Date:	14	Scale:	1:50@A0, 1:200@A4	Drawn by:	
Bourne Estate South for Higgins Construction PLC					
Drawing title: BLOCK 1 Basement Plan					
Reference:	BE14	Draw No:	219	Rev:	A

Date:	15.03.14	Scale:	1:50@A0, 1:200@A4	Drawn by:	
Project:	Bourne Estate South for Higgins Construction PLC				
Drawing title:	BLOCK 1 Ground Floor Plan				
Reference:	BE4	Draw No:	220	Rev:	A

PROJECT: Bourne Estate South for Higgins Construction PLC

Project
BOURNE ESTATE SOUTH REGENERATION

Date	1 MAR 14	Scale	1:50@A0, 1:200@A4	Drawn by	
Project	Bourne Estate South for Higgins Construction PLC				
Drawing title	BLOCK 1 Roof Plan				
Reference	BE14	Comp No	226	Rev	A

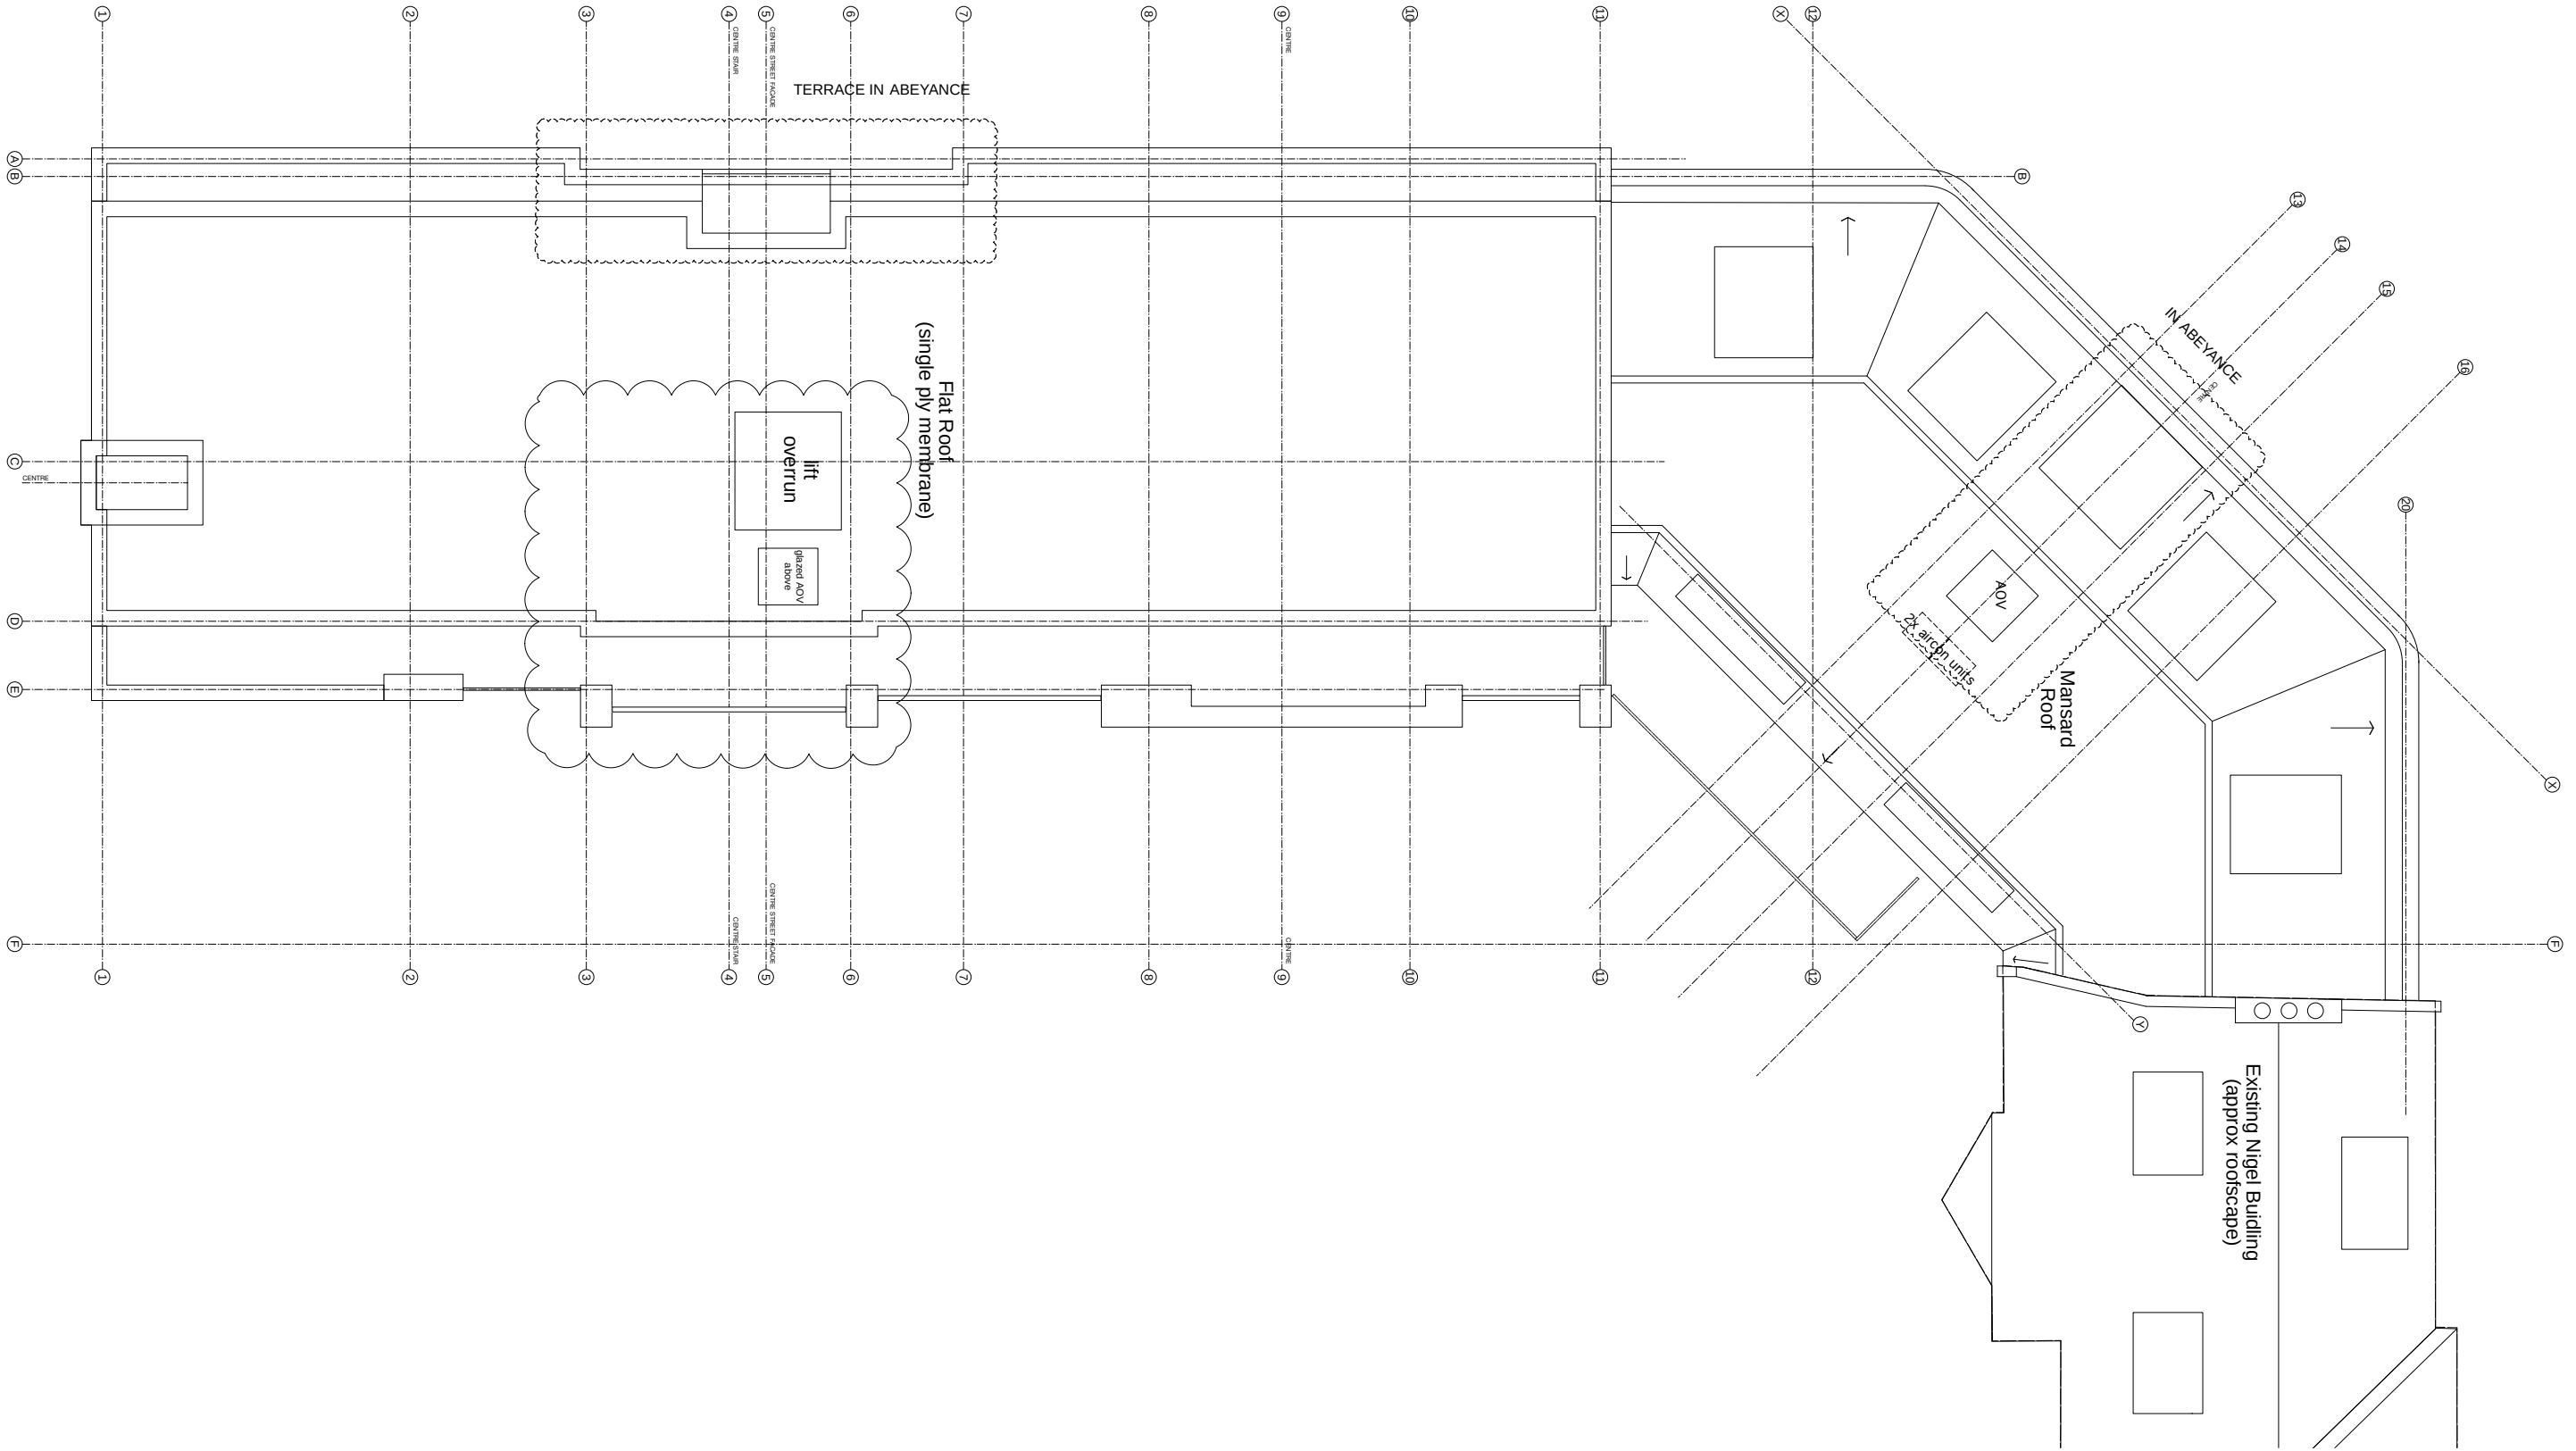
A - 20.05.14 - Canopy removed
Rooflight upgraded to AOV over enclosed
Stair 10
